Access Compliance Report

Public Rights-of-Way

(Curb Ramps)

Intersection ID: 9709	Main Street: PARK_LN	Cross Street: TUCKASEEGEE_RD	Location: W
ADA ID: 4EABF1235665	Ramp Type: BlendTrans2	Initial Pass/Fail: Fail	Overall Compliance: No
Severity Score: 10			
Codes/Mitigation Info/Possible Solution		Field Measurements/Component Compliance

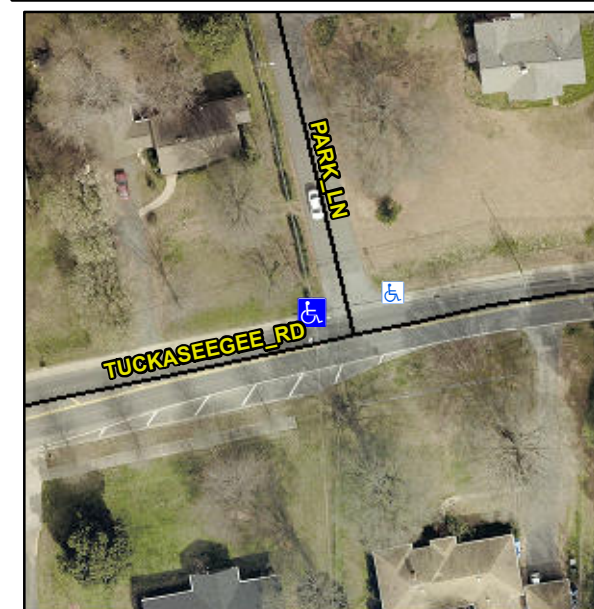
GTR GAP 2.0

R304.5.1, R304.5.3

Compliance	Description	Data	Compliance	Description	Data
N/A	Ramp Length (in)	60.0	Yes	BlendTrans Slope (%)	1.0
No	Ramp Width (in)	37.5	No	BlendTrans XSlope (%)	4.7
N/A	Flare Type LT	N/A	N/A	Flare Type RT	N/A
N/A	Flare Slope LT (%)	N/A	N/A	Flare Slope RT (%)	N/A
N/A	Flare Traversable LT?	N/A	N/A	Flare Traversable RT?	N/A
N/A	Landing Length (in)	N/A	N/A	DWS Provided?	N/A
N/A	Landing Width (in)	N/A	N/A	DWS Contrast?	N/A
N/A	Landing Slope (%)	N/A	N/A	DWS Length (in)	N/A
N/A	Landing X Slope (%)	N/A	N/A	DWS Full Width?	N/A
N/A	Landing Curb? (Y/N)	N/A	N/A	DWS Offset (in)	N/A
N/A	Shared Landing?	N/A			
N/A	Gutter Ponding?	N/A	N/A	Gutter Slope (%)	N/A
N/A	Gutter Lip Ht (in)	N/A	N/A	Gutter X Slope (%)	N/A
N/A	Painted X Walk1?	No	N/A	Painted X Walk2?	N/A
	X Walk 1 Direction	To E		X Walk 2 Direction	N/A
	X Walk 1 Width (in)	N/A		X Walk 2 Width (in)	N/A
	X Walk 1 Slope (%)	2.2		X Walk 2 Slope (%)	N/A
	X Walk 1 X Slope (%)	3.0		X Walk 2 X Slope (%)	N/A

Remove & Replace Curb Ramp With Two New Directional Ramps or Equivalent.
